# Transmittal

**VCA  
Coconut Creek, Fl.**

SEE ATTACHED REVISED SHEET L-4 DATED 2/17/14

L-1

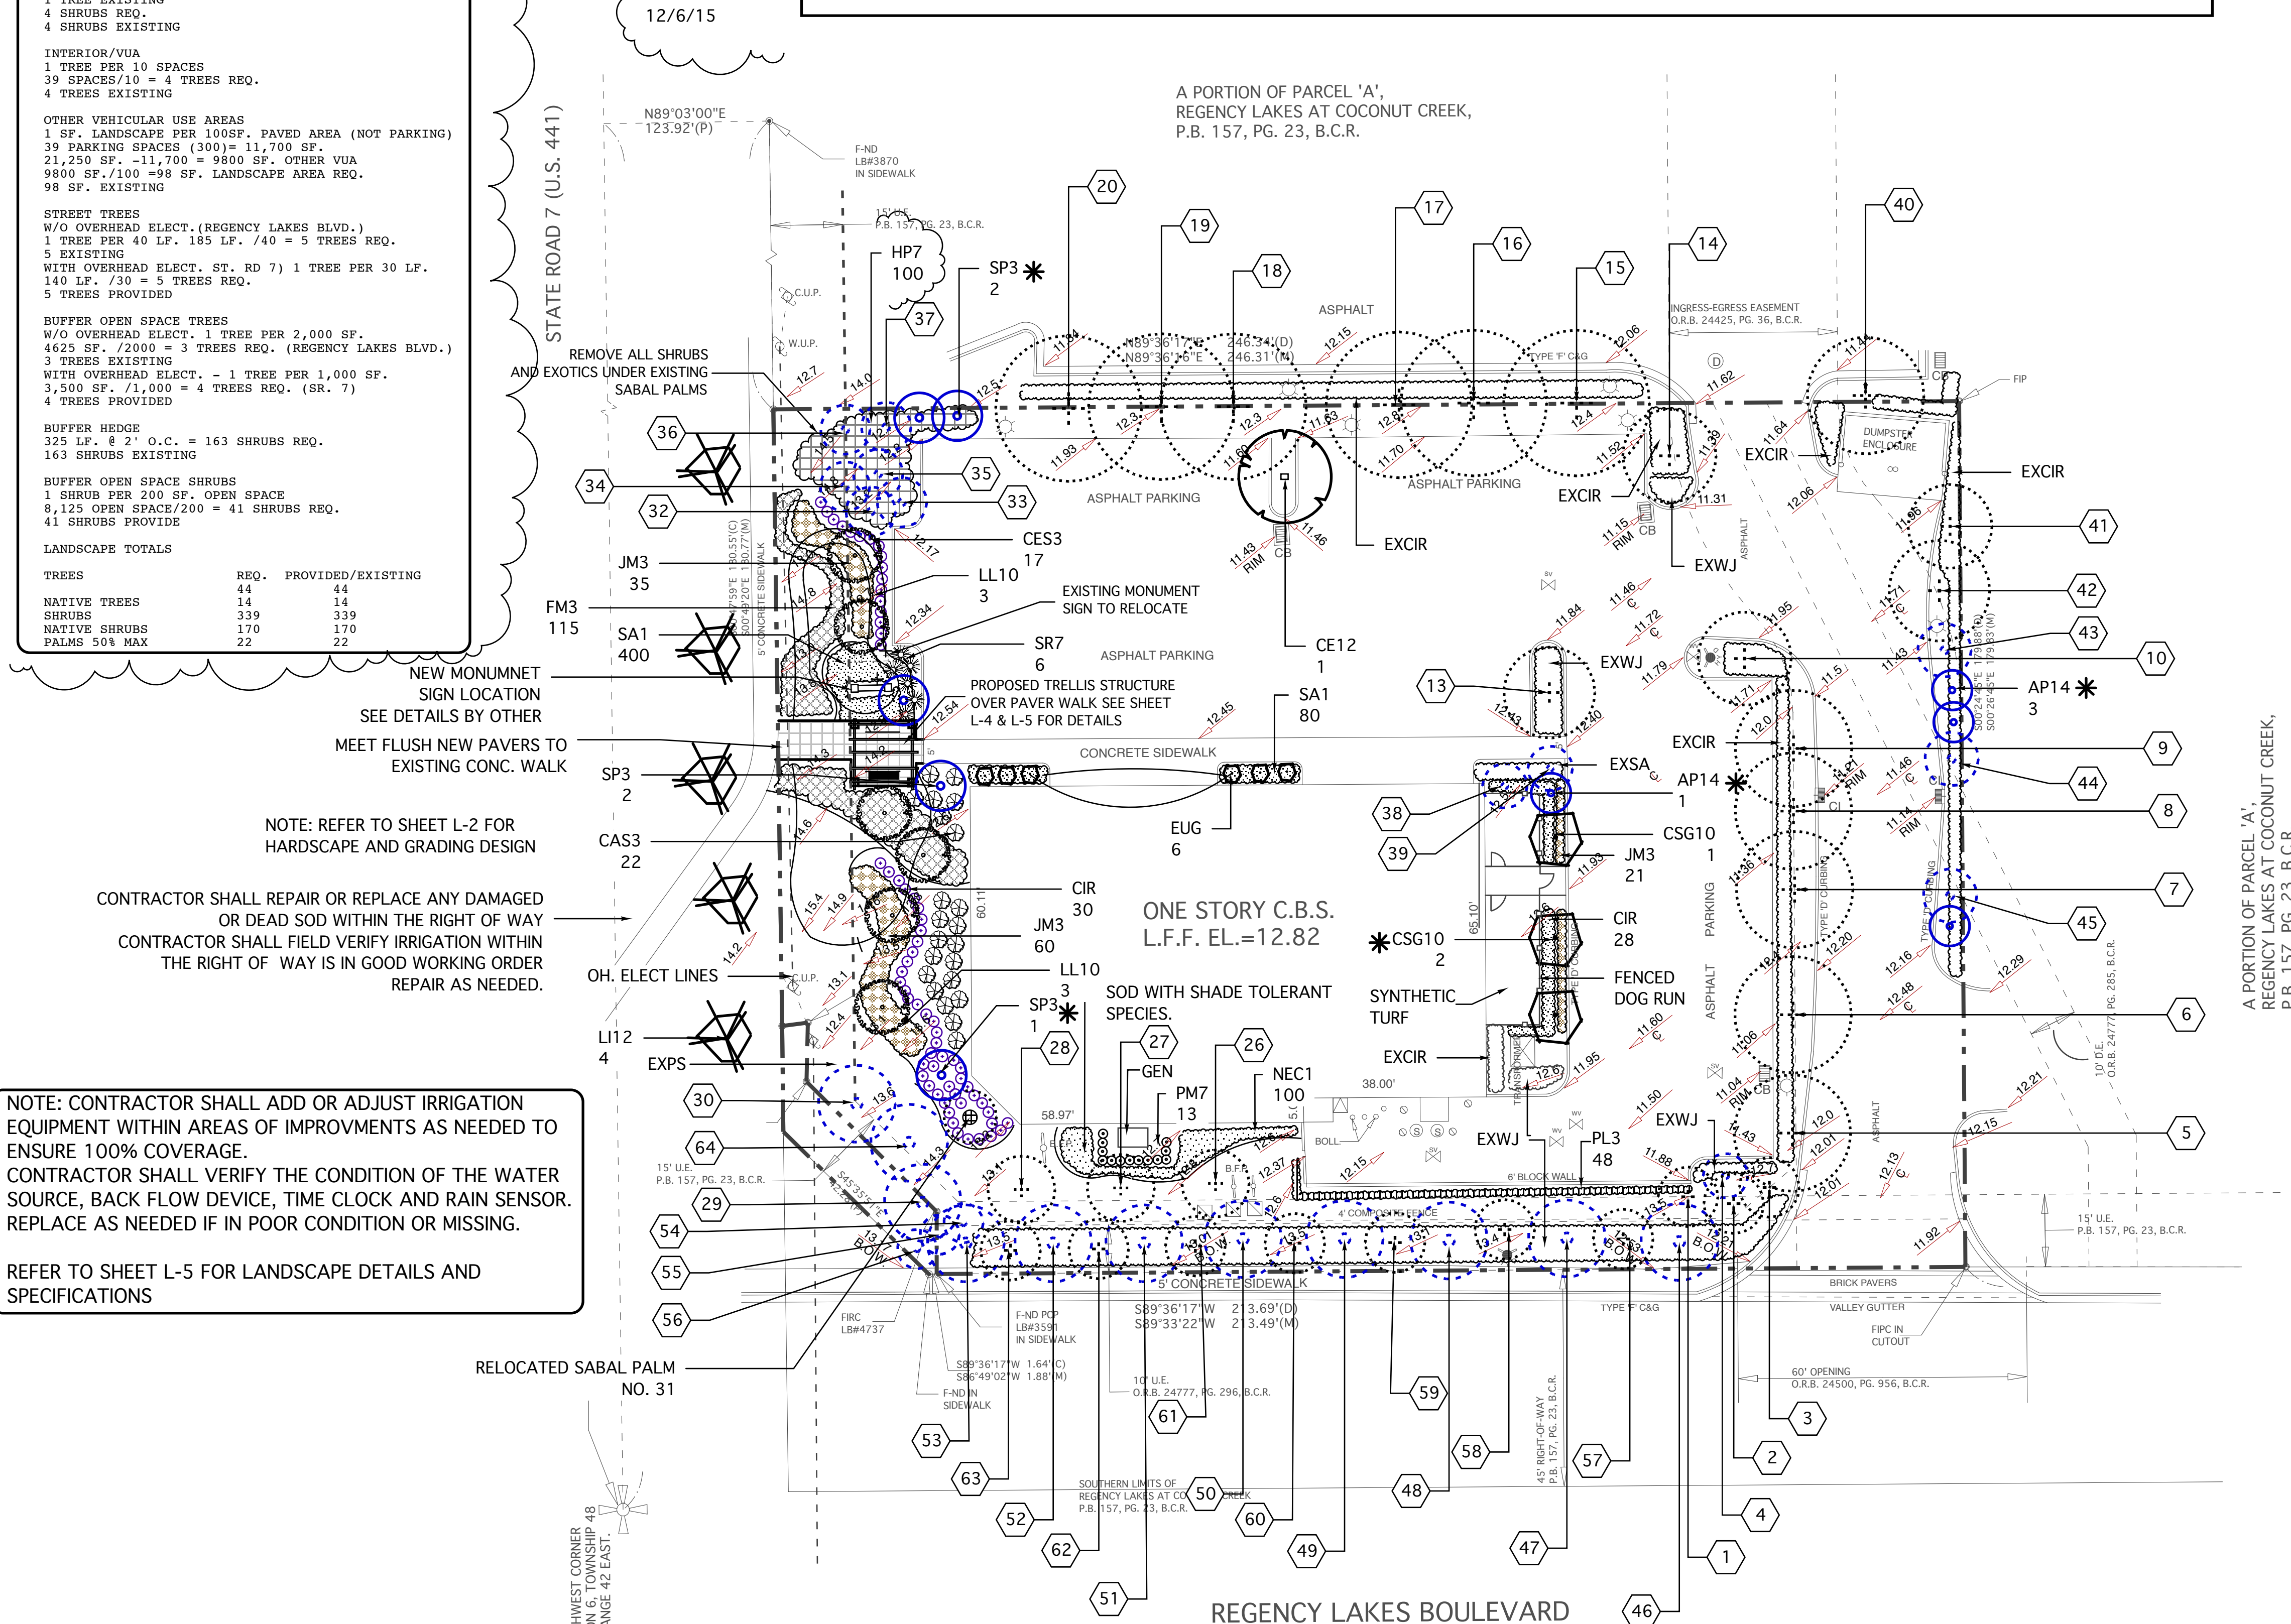
REASON FOR REVISION: PAVER CHANGE DUE TO LACK OF AVAILABILITY FOR PREVIOUSLY SPECIFIED CITY PAVER
